Flight Procedure Tracking Form		Action: FLIGHT CHECK	Task Type: IAP	Date Open: 02/12/2018	Task #: 2018020929165335001	Request #: 20180209291653
Procedure: ILS Y OR LOC Y RWY 8 AMDT 6A			Airport ID: KBUR	Airport: BOB HOPE		Reimbursable #: NO
City: BURBANK	ST: CA	GPS #:	Estimated Chart Date: 02/28/2019		FICO #: 1221202	
Fac ID: BUR		Fac. Type: ILS			Specialist: PETER GUIMOND	
Procedure Review						
	Rec'd	Rel'd	Full Name	Comments		
Lead:	02/14/2018	11/16/2018	TRACEY STILES	QUALITY		
QA:	11/16/2018	11/16/2018	TRACEY STILES	13		
Liaison:	11/16/2018	11/16/2018	MARY MCDONALD	CHECKED		
Procedure Comments:			Remark Type: INFORMATION			
<p>ACTIVE DATA USED.</p> <p>CONTACT: ROBERT HAMILTON, AJV-5422 LEAD, 405.954.4608</p> <p>12/10/2018: THIS IS AN UPDATED COPY OF THE FORM DEVELOPED ON 09/12/2018:</p> <ol style="list-style-type: none"> 1. AMENDED NOTE LOCALIZER UNUSABLE WITHIN 0.5 NM TO THLD TO READ LOCALIZER UNUSABLE WITHIN 0.9 NM TO THLD - FLIGHT INSPECTION RESULTS. 2. AMENDED S-LOC 8 MISSED APPROACH POINT FROM 5.41 NM AFTER BUDDE OM/INT TO 5.17 NM AFTER BUDDE OM/INT - RECOMPUTED USING UPDATED LOCALIZER RESTRICTION. 3. AMENDED (CFBXN) LAT/LONG FROM 341153.12N/1182256.63W TO 341153.35N/11823

ILS Y or LOC Y RWY 8
BOB HOPE (BUR)

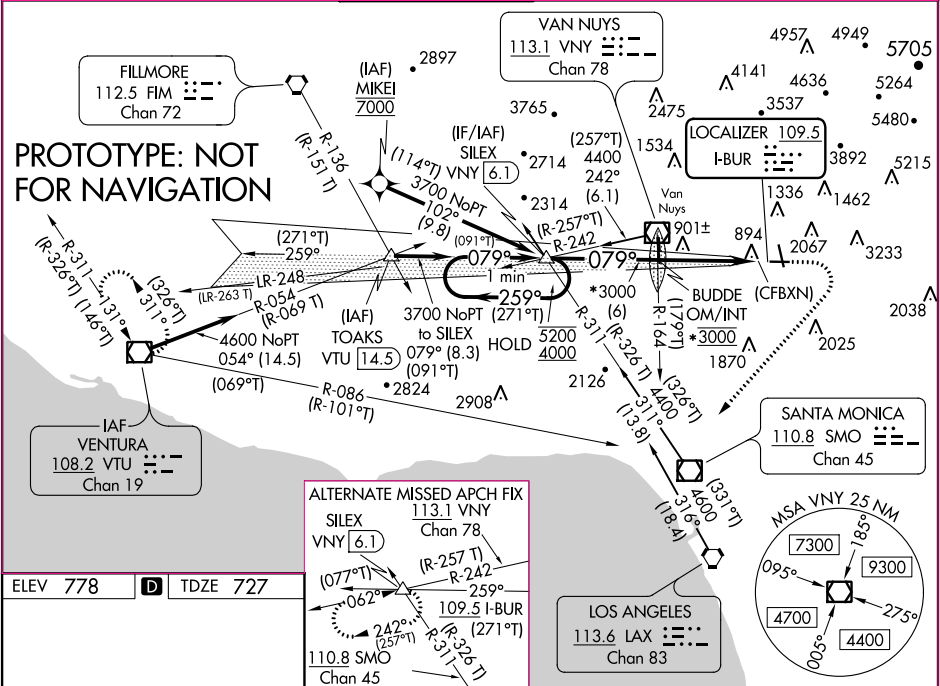
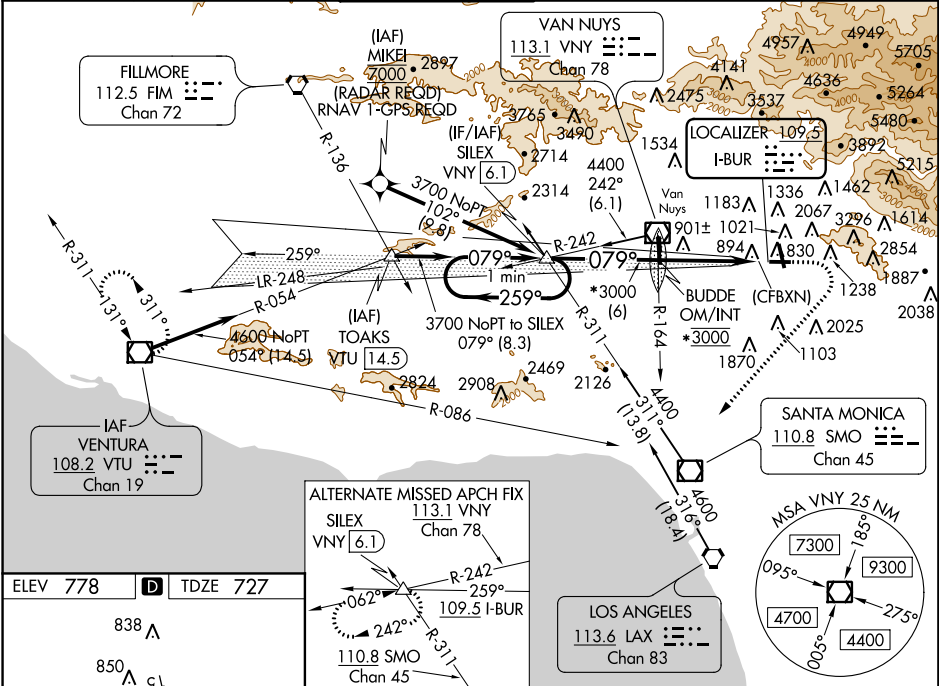
FLIGHT INSPECTOR SIGNATURE: gary j veer @ 12/03/2018 12:09			PRINTED NAME: VEER, GARY JOHN			NOTAM INITIATED? <input type="checkbox"/> YES <input checked="" type="checkbox"/> NO
FLIGHT INSPECTOR REMARKS: Special inspection of updated procedure. Notes changed. BOB HOPE, BURBANK, CA, ILS Y or LOC Y RWY 8, AMDT 6A, SAT w/CHANGES. New restriction issued for LOC. LOC unusable inside of 0.9 NM to thld. NOTAM issued by (AC), 12/03/2018 . !BUR 12/005 (KBUR A0995/18) BUR NAV ILS RWY 08 LOC INSIDE 0.9NM UNUSABLE PLUS SEE U.S. CHART SUPPLEMENT 1812031543-PERM. FIDEX to be issued to update DS, Chart Supplement and SIAP.						
IN-FLIGHT OBSTACLE REPORT						
OBSTRUCTION ID #:	COORDINATES OR LOCATION:	GNSS ALTITUDE (MSL):	BAROMETRIC ALTITUDE (MSL):	HEIGHT ABOVE GROUND LEVEL:

ELEV 778  TDZE 727		One Minute Holding Pattern		1800	4600	VTU	VTU
079° 6.1 NM from FAF		VGSI and ILS glidepath not coincident (VGSI Angle 3.00/TCH 72).				VTU R-086	
5200 ← 259°		SILEX VNY (6.1)		2753		*3000	
4000 → 079°		(091°T)		3700		3000	
GS 3.00° TCH 60		6 NM		5.2 NM		0.9	
MIRL Rwy 15-33 HIRL Rwy 8-26 REIL Rwy 15, 26 and 33		CATEGORY		A		B	
FAF to MAP 5.2 NM		S-ILS 8		1555-2½		828 (800-2½)	
Knots 60 90 120 150 180		S-LOC 8		1620/50		893 (900-1)	
Min:Sec 5:12 3:28 2:36 2:05 1:44		 CIRCLING		1620-1¼		1640-1¼	
BURBANK, CALIFORNIA		842 (900-1¼)		862 (900-1¼)		2240-3	
Amdt 6A FIG		34°12'N-118°22'W		1462 (1500-3)		2320-3	
						1542 (1600-3)
